North Kesteven District Council response to the Examining Authority's written questions and requests for information (ExQ2) issued on 19 December 2023

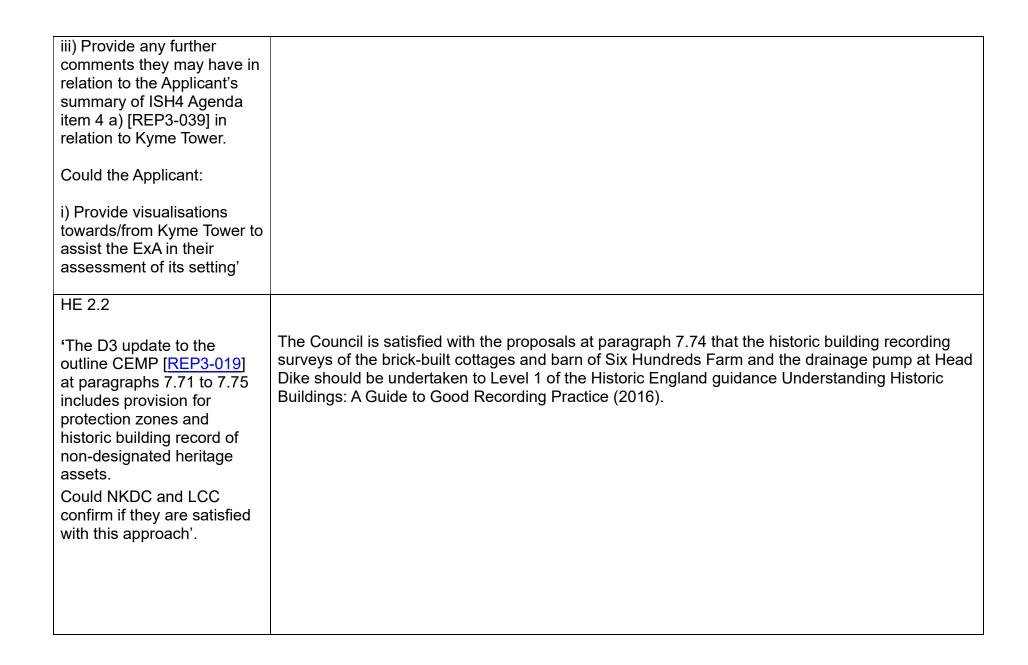
10.5.17/10.5.18 – We agree that the elements of setting referred to however the applicant has already stated that "long-ranging views in all directions" contribute to the significance of Kyme Tower. As such, paragraph 10.5.18 contradicts this point by stating that intervisibility is incidental. In the Council's view no views can and should be classed as 'incidental' due to the nature of the asset.

10.5.19 – There is an acceptance that the solar park may be contained within the views. There is no explanation of the "distinctly modern character" which is referenced. The open agricultural character is one that has been established for hundreds of years and would not be significantly different from that which that which currently exists.

In summary, the Council's position remains that the impact of the proposed solar park on the setting of Kyme Tower has been insufficiently tested. The applicant acknowledges that long-ranging views in all directions contribute to the significance of the tower, yet there is still an attempt to de-scope the heritage asset by referring to the views as incidental, therefore being contradictory. The Council's position remains that the impacts may be negligible and is anticipated to result in less than substantial harm at the lower end of the scale, however there is still a degree of impact in the Council's opinion and that needs to be assessed accurately.
